STATE OF DELAWARE
DEPARTMENT OF NATURAL RESOURCES & ENVIRONMENTAL CONTROL
OFFICE OF THE SECRETARY

DELAWARE COASTAL
MANAGEMENT PROGRAM

RE: Final EIS for an Early Site Permit at the PSEG Site
DNREC Outstanding Concerns Relative to Groundwater Withdrawals

Figure 1 Water levels recorded at DGS observation well EC52-07, located approximately 7.4 miles northwest of the Salem Power Plant.

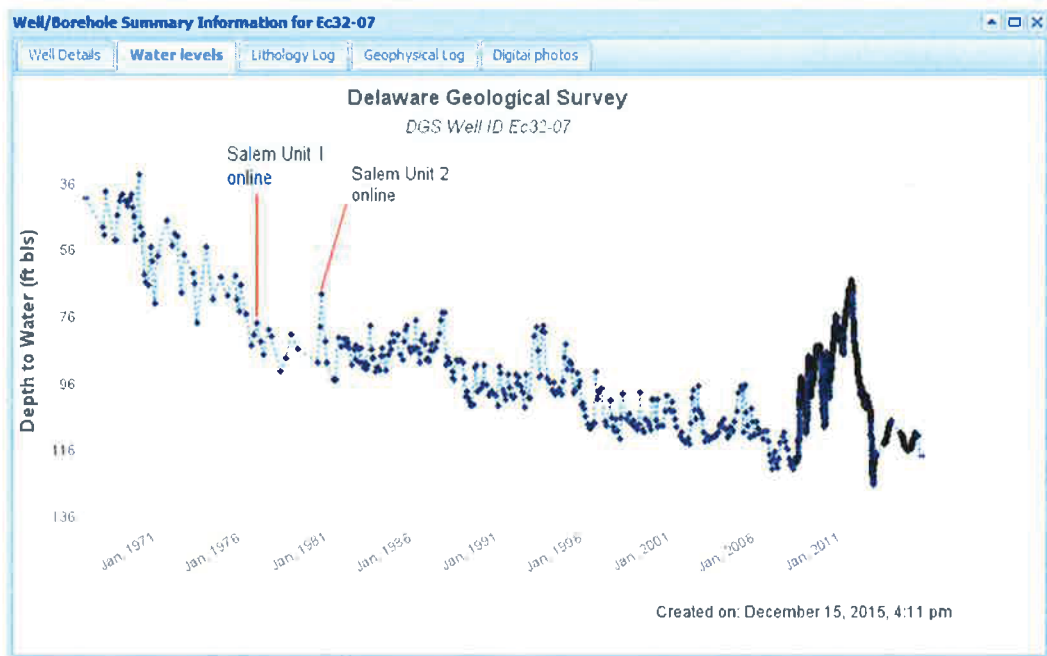
The implication that our question concerned the maximum, emergency withdrawal rate (953 gpm) is misrepresented. The current withdrawal rate at the Salem facility, at an average rate of 379 gpm as stated on EIS 7-13, Line 29, may have caused part of the long-term decline in water levels in the Potomac aquifer in southern New Castle County. The water levels recorded

DGS observation well EC52-07, located approximately 7.4 miles northwest of the power plant illustrates this trend (Figure 1).

Some part of the approximately 30 feet of decline in water levels since 1977 are likely attributed to the withdrawals at the Salem facility. DGS observation well Ec52-24 located approximately 6.24 miles west-northwest, does not have as long a record of water levels, but even in the 10-year period of record, there is a downward trend (Figure 2).

Figure 2 Water levels recorded at DGS observation well Ec52-24 located approximately 6.24 miles west-northwest of the Salem Power Plant.

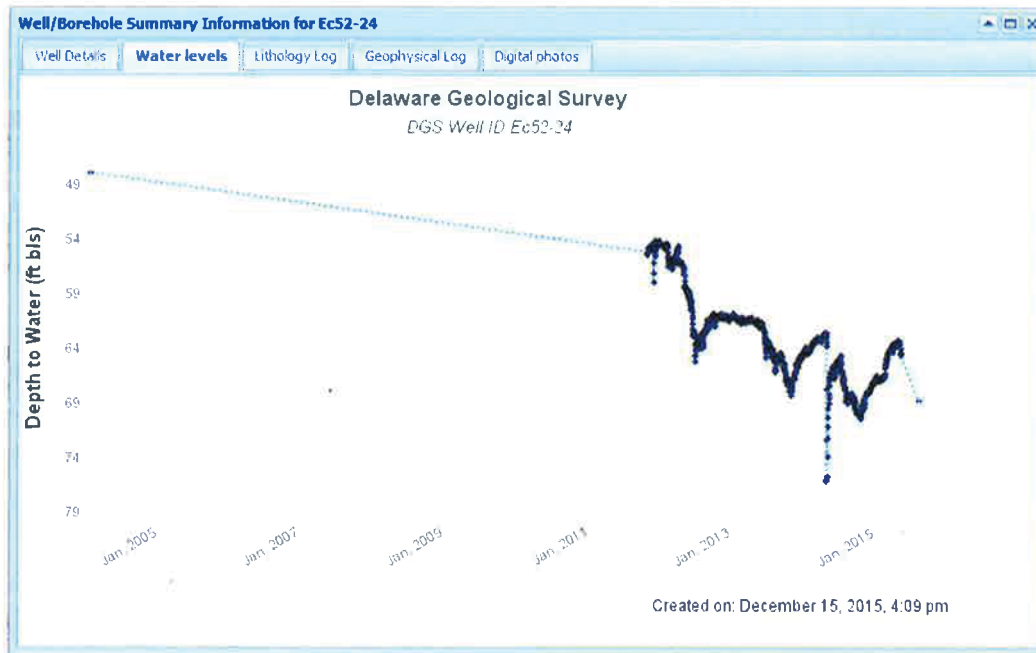
There are five public water supply wells located 6 to 7 miles west of the Salem facility. Extrapolating the estimated drawdowns presented in the EIS (14.4 feet at 5 miles from the facility), the expected drawdown at the nearest public supply well after 30 years pumping at 210 gpm is 12 feet. With the existing facility and the new unit in operation simultaneously, the expected drawdown at the nearest public well in Delaware is 41 feet, after 30 years of operation at 589 gpm. These wells could experience drawdowns of 12 to 60 feet at different times of year, with the greatest impacts during the summer months when public supply demand is also at its peak. The EIS refers to these impacts and the loss in capacity that will be a result of as “minor”. DNREC hydrologists consider them “significant”.
